Docket No. 11-AFC-01

**Rob Simpson, Helping Hand Tools and Mr. Powers’ Response to Pio Pico PMPD
Alternatives Comments**

**APPLICATION FOR CERTIFICATION
FOR THE *PIO PICO ENERGY CENTER PROJECT***

Figure 1. Multiple PV Sites Smooth Aggregate PV Output on Partly Cloudy Days

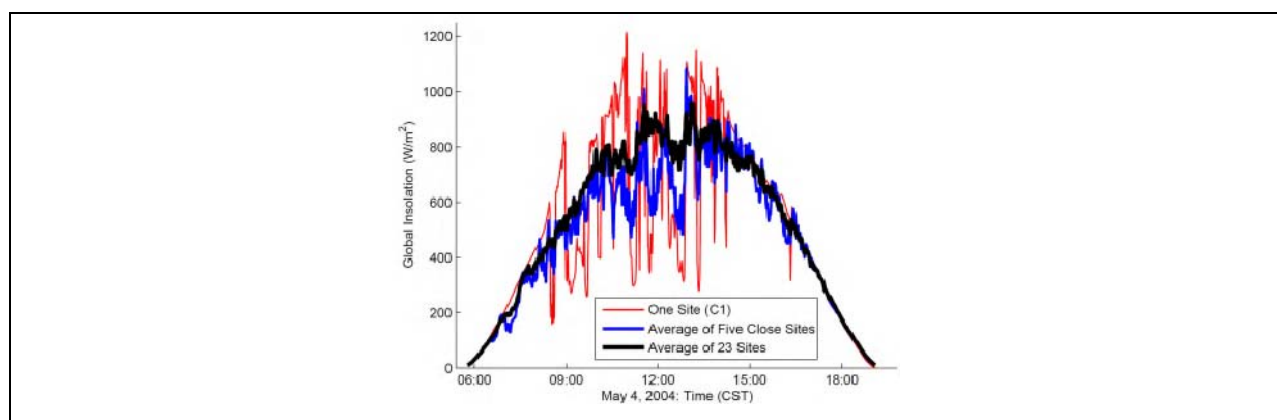
This is factually incorrect as it relates to distributed PV resources. Distributed PV is predictably available in aggregate on days with scattered clouds, when the output of multiple geographically-dispersed PV systems is combined.⁴ This output characteristic of multiple-geographically dispersed distributed PV systems is shown in Figure 1.

There is no need for additional fast response peaking units to address distributed PV output variability. Distributed PV output is either a clear day bell curve, a partly cloudy day “flattened” bell curve as shown in Figure 1, or a cloudy day with no output. None of these scenarios require fast response output from peaking units.

Figure 2. SDG&E Hour-to-Hour Load (MW), September 27, 2010

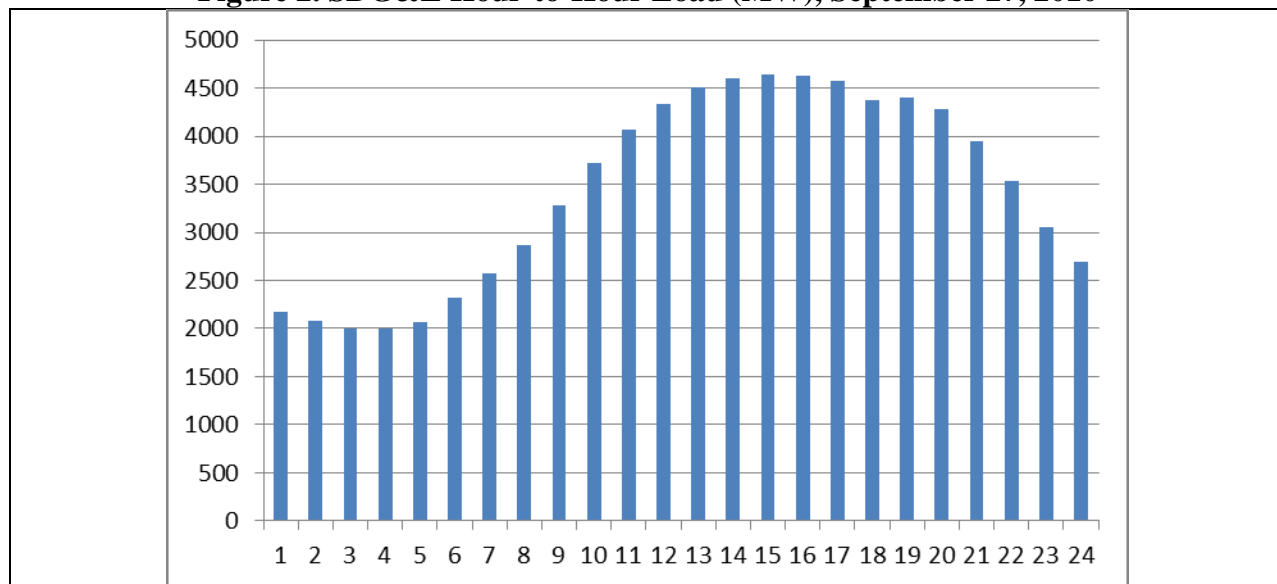
The CEC fails to state that demand already changes rapidly in SDG&E territory due to widely varying load over the course of a 24-hour day. Figure 2 is a bar chart showing hourly demand in

SDG&E service territory over 24 hours on September 27, 2010, the day that SDG&E recorded the highest one-hour demand in 2010.⁶ Demand increased nearly 450 MW per hour from 10 am to 11 am on September 27, 2010. Demand declined nearly 500 MW per hour from 10 pm to 11pm. SDG&E territory is already equipped with sufficient peaking resources to address rapid changes in load.
